Planning Commission
Council Chambers
September 20, 2022 – 6:00 p.m.
233 South Main Street, Monroe, Ohio

TO: Members of the Monroe Planning Commission
FROM: Kameryn Jones
Assistant Development Director

DATE: September 20, 2022
RE: Information Packet for September 20, 2022 Planning Commission Meeting at 6:00 p.m.

I. Case No. 2022-9-9— Consideration of Site Plan Application for an Office Warehouse Facility on Baker Drive.

Proposed Retail Center For:
WARREN DISPENSARY
Monroe, Ohio

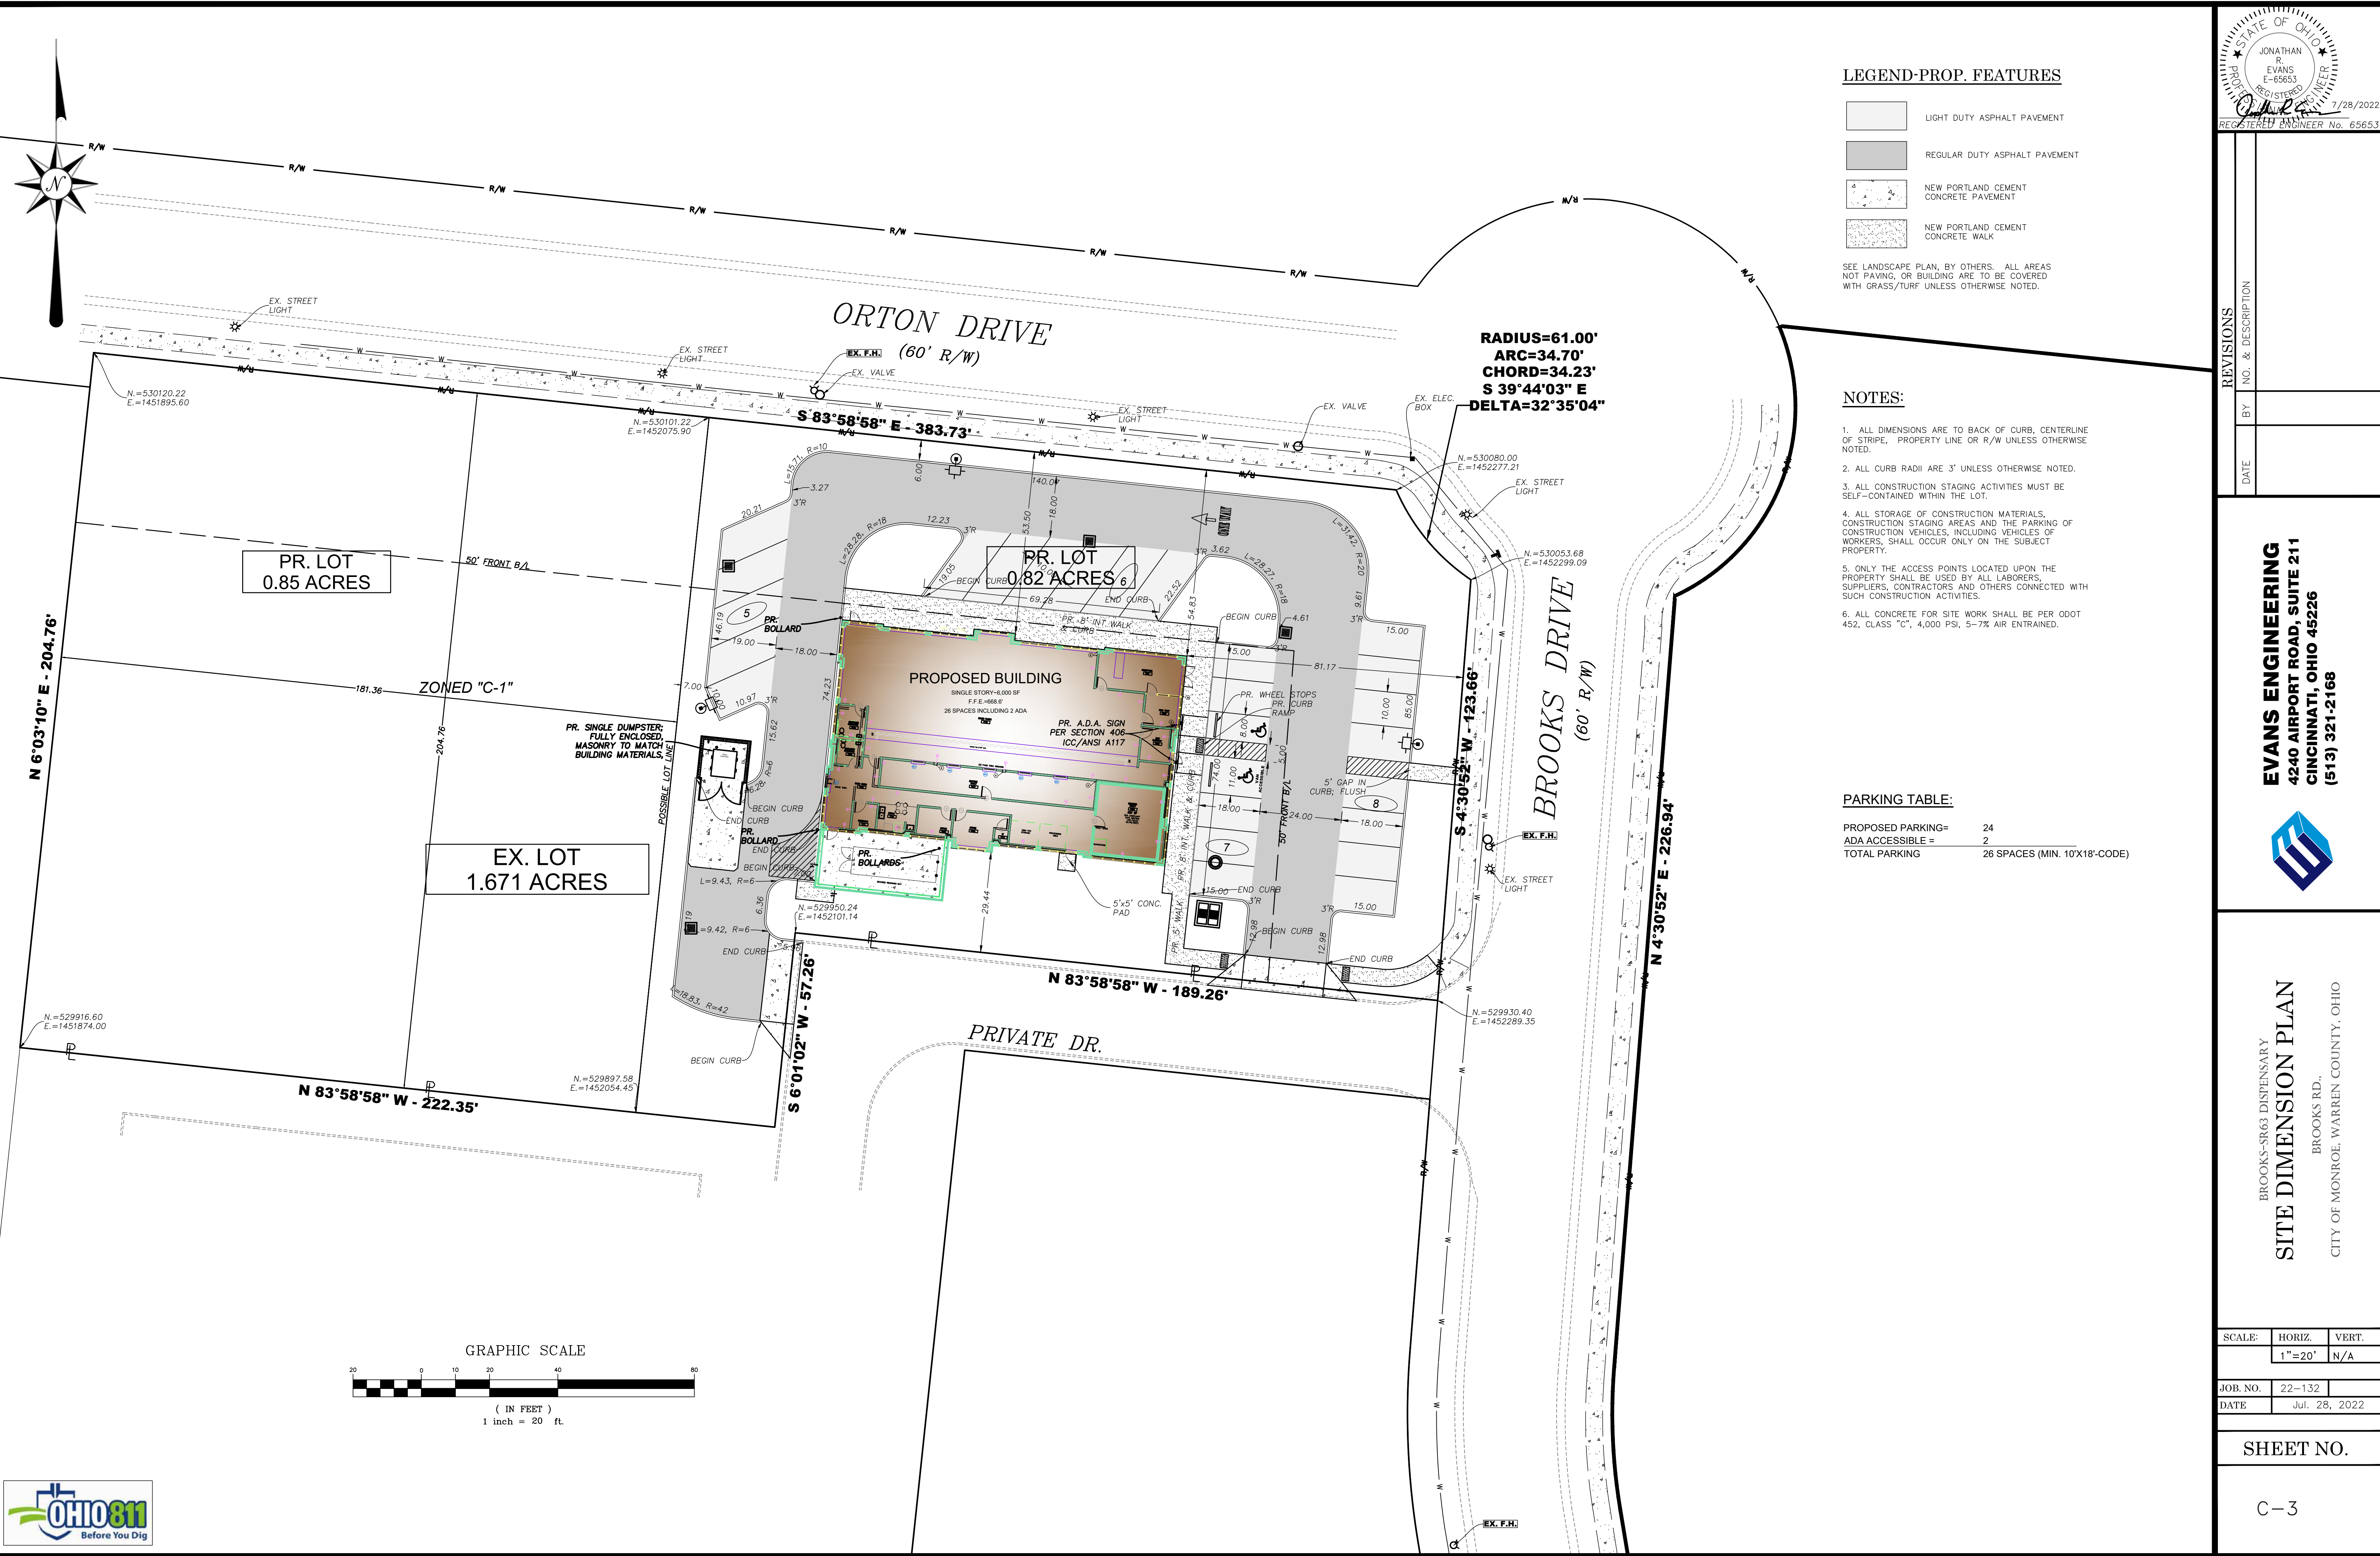
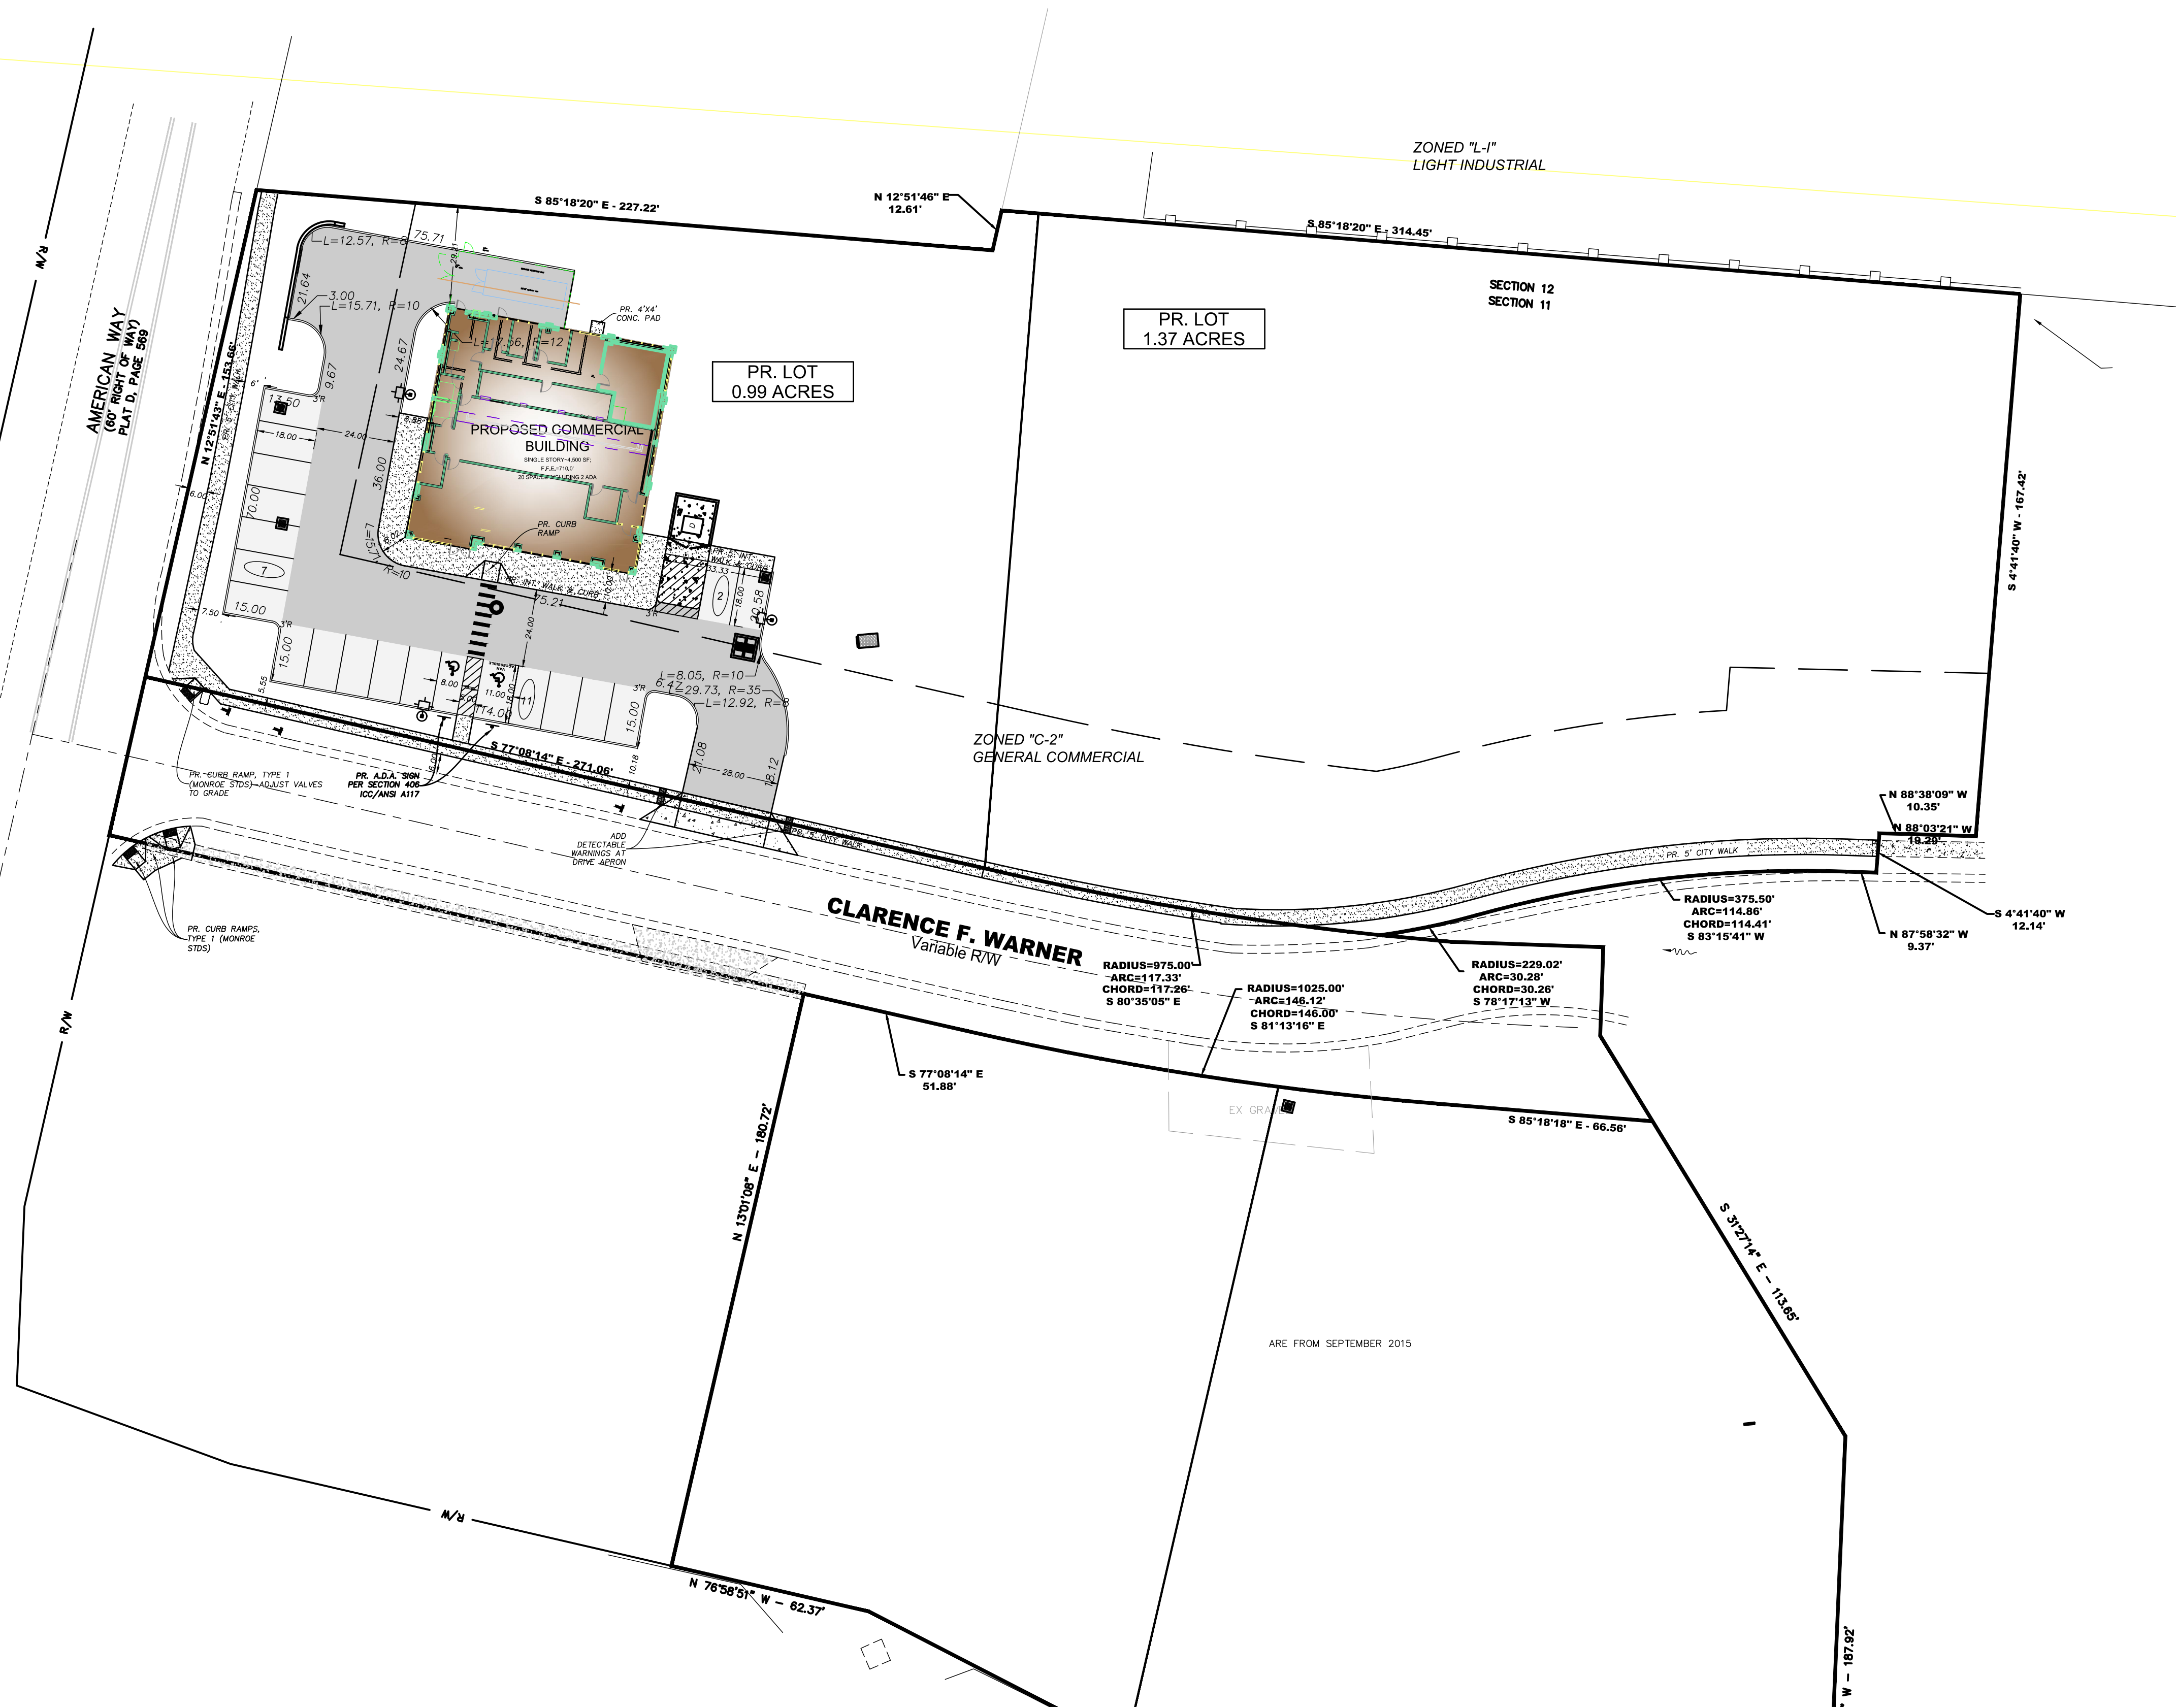
- At the July 19th meeting, Planning Commission approved Case No. 2022-7-7, a site plan for a medical marijuana dispensary located on Brooks Drive.
- After Planning Commission approval, the applicant approached staff regarding the already approved architectural elevations with a proposed change, primarily to the materials and color of materials.
- Code Section 1203.06(l) Amendments of an Approved Site Plan provides the Code Enforcement Officer with the ability to approve minor changes to an approved site plan or to refer the request to Planning Commission for their consideration.

- Staff does not oppose the proposed change in elevations as they still meet minimum code requirements in regards to permitted material types.
- Percentages of base-body-cap design elements, windows, and required building offsets are still met.

- Staff recommends approval of the amendment to approved site plan for Case No. 2022-7-7.
